**Airly Mine Extension Project (SSD 5581)
Mt Airly Panel and Pillar Zone Extraction Plan – Modification 2**

I refer to your letter dated 22 January 2021 requesting a modification (Modification 2) of the Mt Airly Panel and Pillar Zone Extraction Plan (EP) for miniwall (MW) panels MW10 – MW12, which was submitted in accordance with Condition 7 of Schedule 3 of the consent for the Airly Mine Extension Project (SSD 5581). Modification 2 proposed a revised pillar and maingate design for MWs 10-12 and an extension to the length of MWs 11 and 12 outside areas previously approved for secondary extraction (refer to **Attachment A**). Conditional approval of the revised pillar and maingate design was provided by the Planning Secretary on 15 February 2021, however secondary extraction within the proposed extension areas of MWs 11 and 12 was not approved.

Attachment A

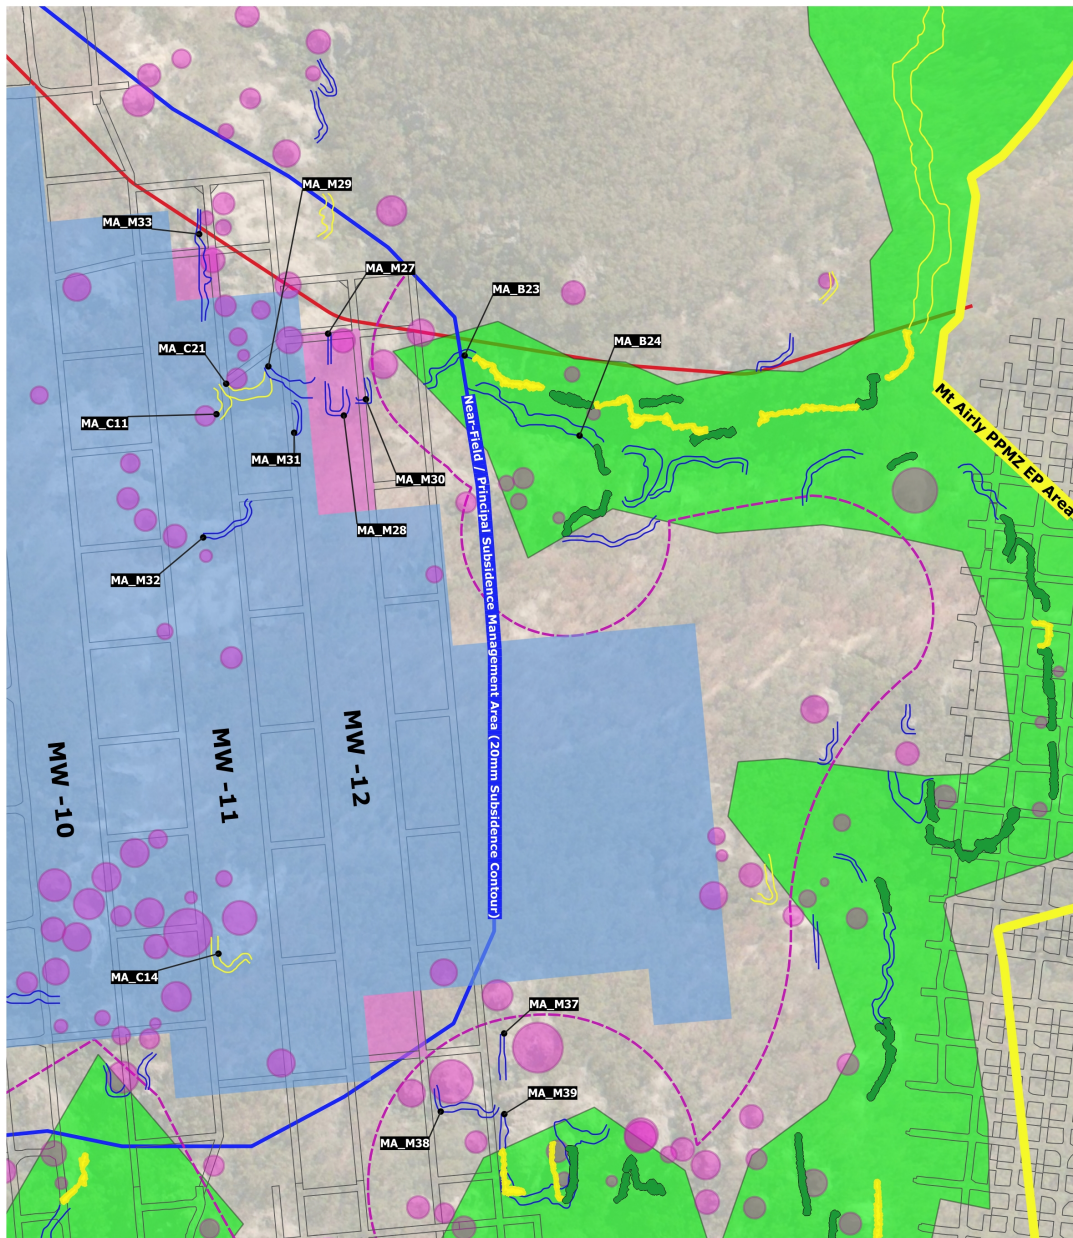
The Department has carefully reviewed the supporting information in consultation with the Airly Mine Independent Expert Panel. The Department notes that potential subsidence impacts on land and biodiversity features within the extension area of MWs 11 and 12 (pink shaded areas within the figure in **Attachment A**) are expected to meet performance measures outlined in the development consent (SSD 5581).

The Department notes however that achieving these performance measures relies in part on the amended pillar and maingate design achieving predicted reductions in subsidence levels. Given the presence of sandstone features within the MW11 and 12 extension areas, the Department considers it appropriate for Centennial Coal to demonstrate that predicted subsidence levels have been achieved at the conclusion of mining MW10 prior to commencing secondary extraction within the MW11 extension area, and again at the conclusion of mining MW11 prior to commencing secondary extraction within the MW12 extension area.

- Following the completion of secondary extraction in MW10 and prior to secondary extraction commencing in MW11, Centennial Coal must demonstrate to the satisfaction of the Planning Secretary that subsidence levels are within predicted levels and that the subsidence impacts

performance measures outlined in Table 1 of Schedule 3 of the development consent are expected to be met.

- Following the completion of secondary extraction in MW11 and prior to secondary extraction commencing in MW12, Centennial Coal must demonstrate to the satisfaction of the Planning Secretary that subsidence levels are within predicted levels and that the subsidence impact performance measures outlined in Table 1 of Schedule 3 of the development consent are expected to be met.
